# SERVICE BULLETIN

BULLETIN NO: AM-375-RPJ

EQUIPMENT: MW-1A PA MODULES

SUBJECT: History of updates to MW-1A PA Module.

FIGURE 8-3. RF/PA MODULE  
A1-A13, SCHEMATIC  
828 8512 001-A

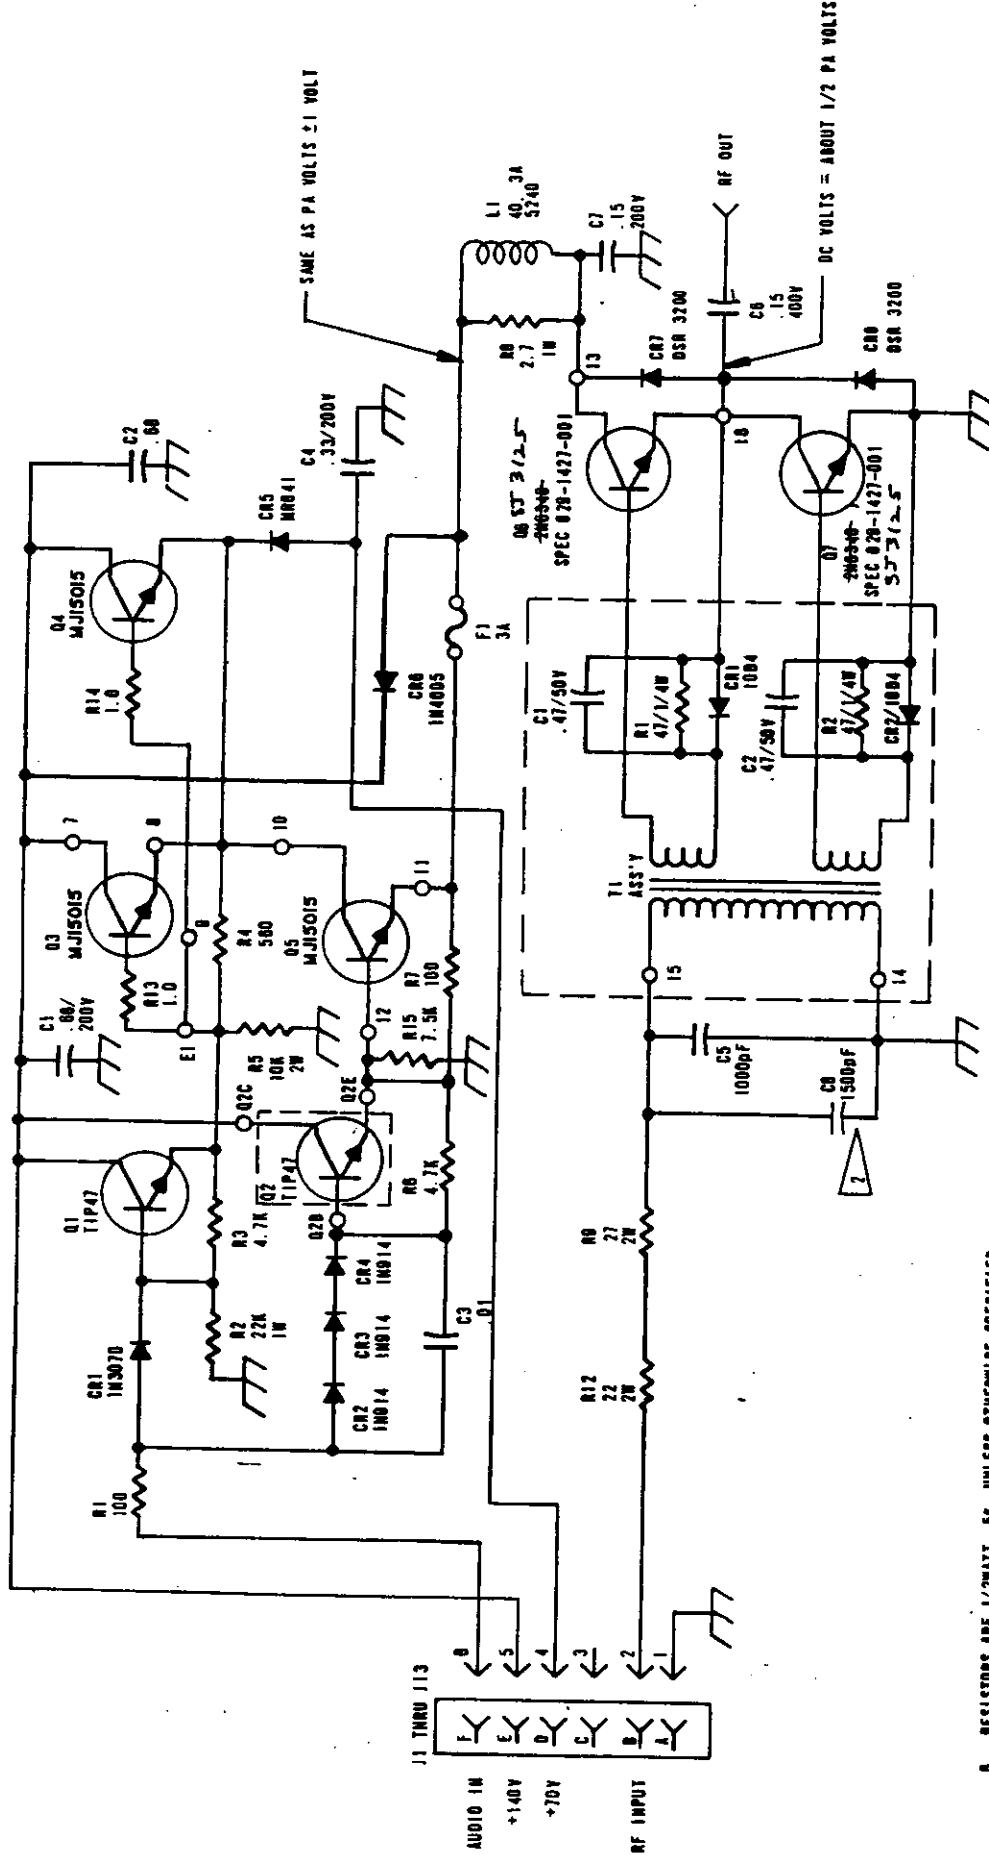
1. Transistors sockets XQ-6 and XQ-7, 404-0661-000.
2. Resistor R11 and Pot R10 removed.
3. Resistor R12 = 22 ohm, 540-0571-000.
4. Resistor R9 = 27 ohm, 540-0573-000.
5. CR6 = 1N4005, 384-0020-000. See AM-141-CKH.
6. RF Input Board is installed, 992-5217-001, T1.
7. Q6 and Q7 must be SJ3125 transistors, 380-0513-000
8. Verify that Q2 is wired per revision N schematic.
9. Verify that DSR 3200 diodes are installed across Q6 and Q7, 384-0678-000. See AM-120-LAP.
10. Q3, Q4 and Q5 = MJ15015, 380-0670-000.
